Insert new subclause 145.5.3.7.0a below 145.5.3.7 as follows:

145.5.5.1a Transitions between 2-pair and 4-pair mode (dual-signature)

Figure 145–44—Dual-signature PD power control state diagram for 4-pair mode

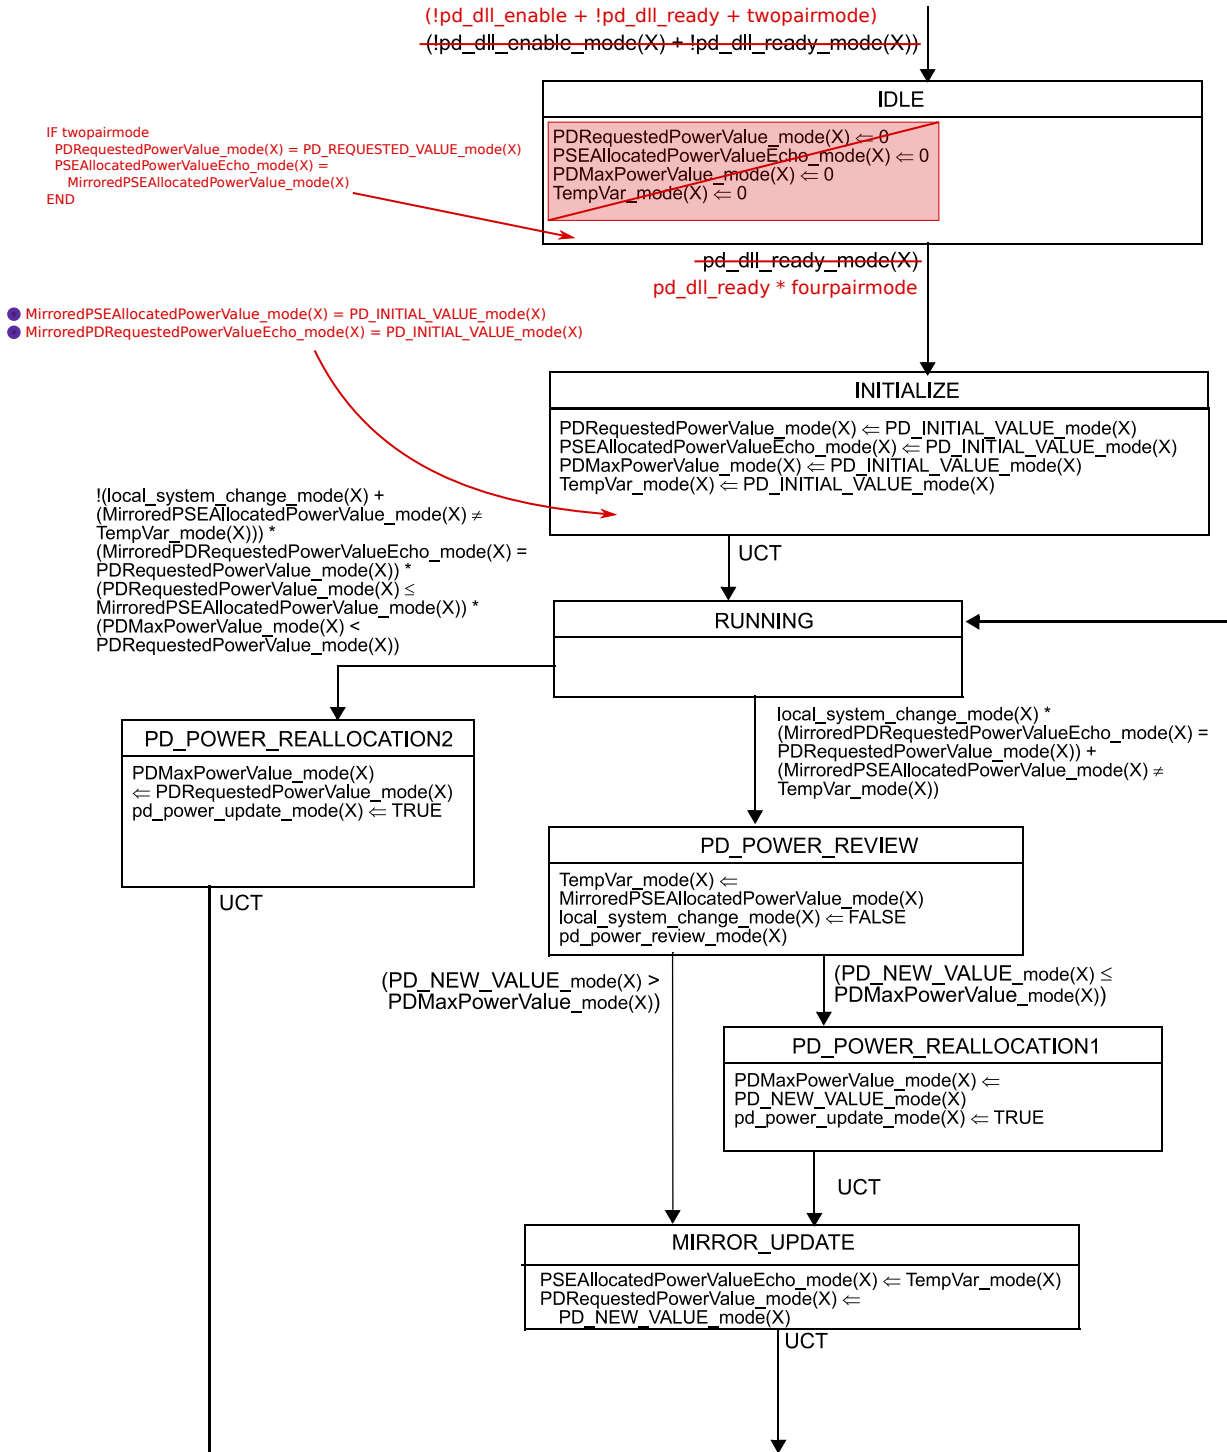
Change Figure 145–44 as follows:

Figure 145-44a --- Dual-signature PD power control state diagram for 2-pair mode

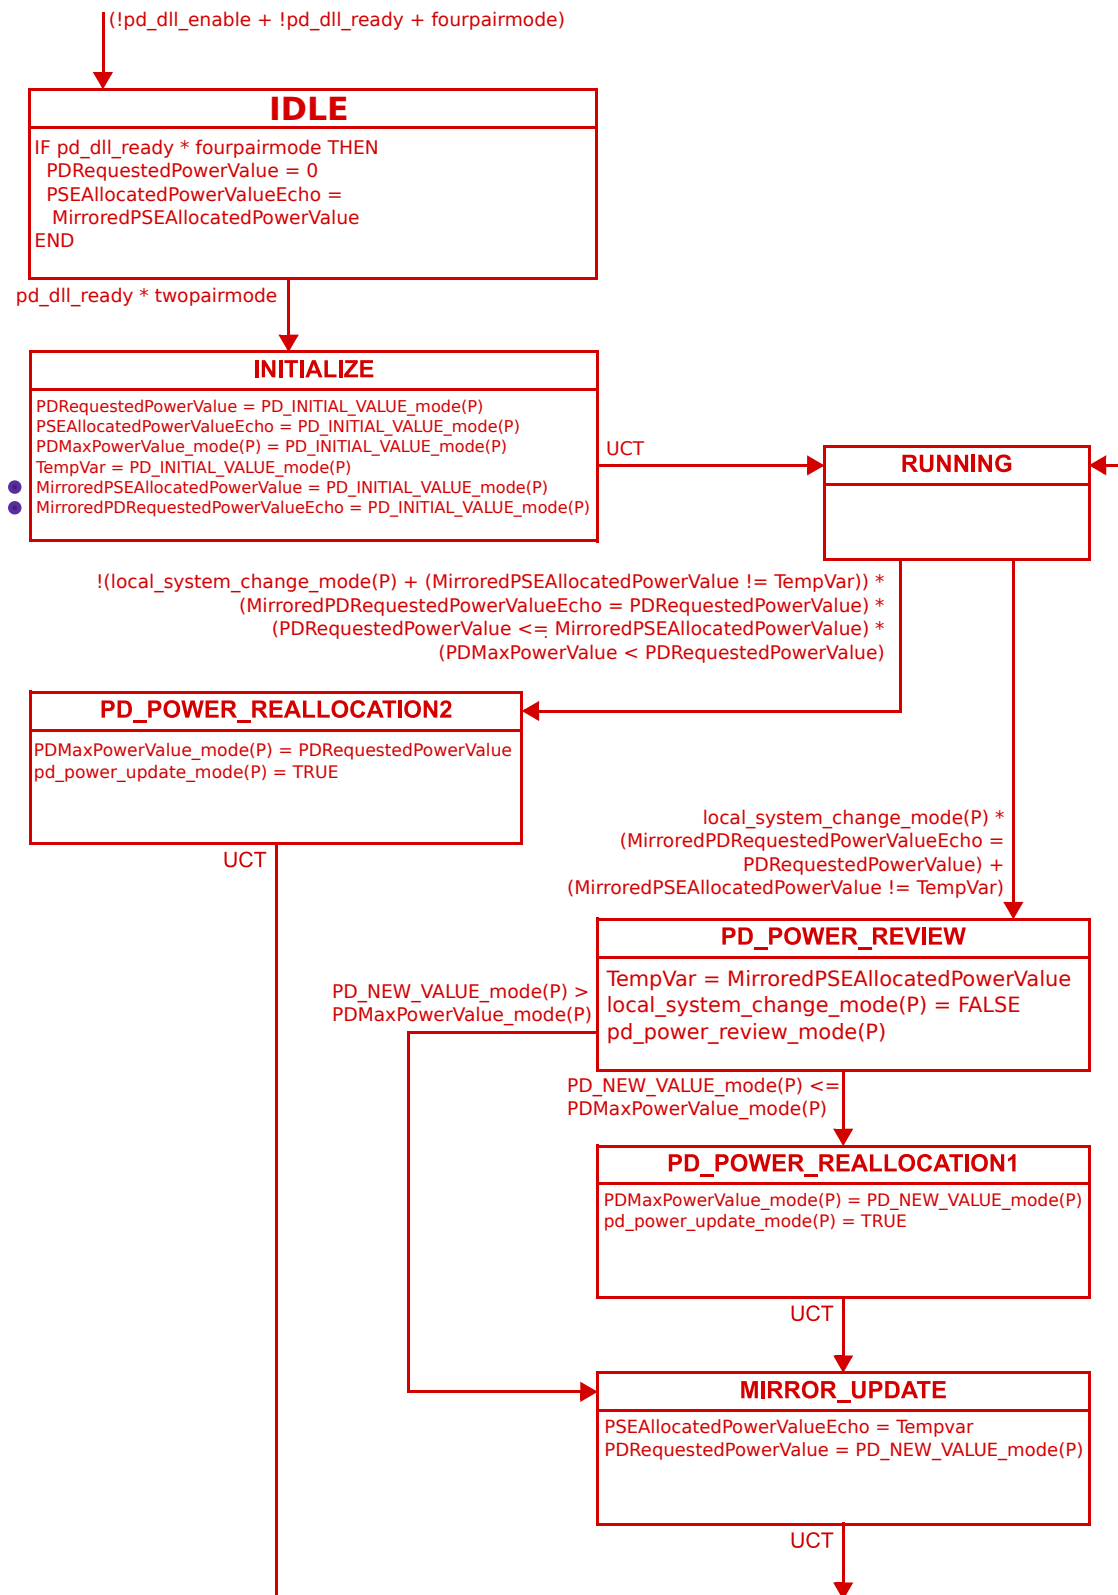
Insert Figure 145–44a as follows:
